UNITED STATES PATENT AND TRADEMARK OFFICE

APPLICATION NO.	FILING DATE	FIRST NAMED INVENTOR	ATTORNEY DOCKET NO.	CONFIRMATION NO.
09/492,369	01/27/2000	William E. Blaha		9790

Office Action Summary

DETAILED ACTION

EXAMINER'S ATTACHMENT 1

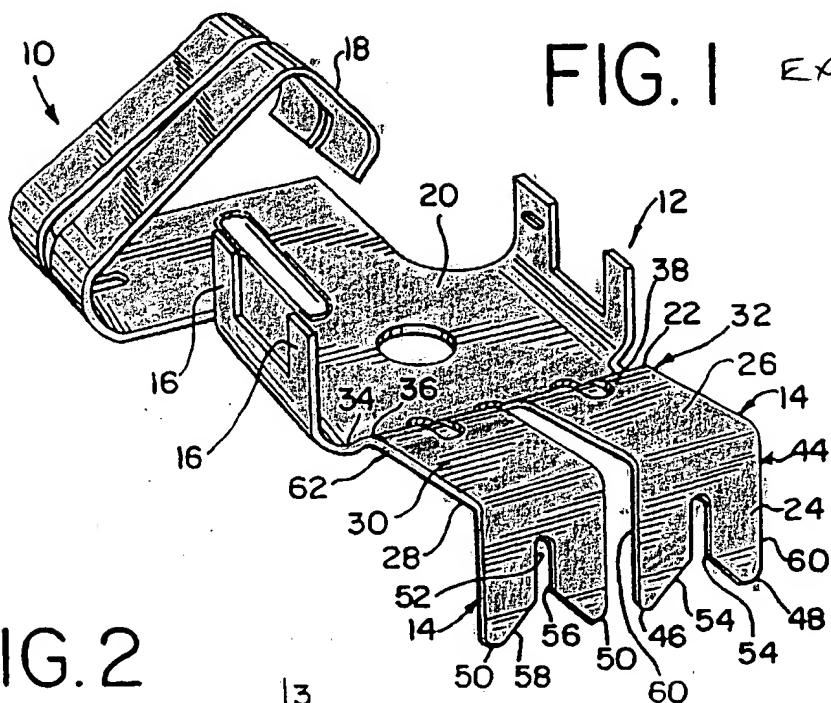
an electrically conductive clip (red portion, see Examiner's attachment) disposed entirely within the cavity and held fixed in the housing by the wall (E1, see Examiner's attachment) having at least first and second retaining finger (14, 14) and has a plurality of tines (24) forming an insulation displacement type contact, each of which engages an individual conductor (80) to

a blade-type electrically conductive extension (blue portion, see Examiner's attachment) in shorting electrical engagement with the clip and extending through a housing wall to an exterior of the housing, at least a portion of the extension on the exterior of the housing being electrically conductive.
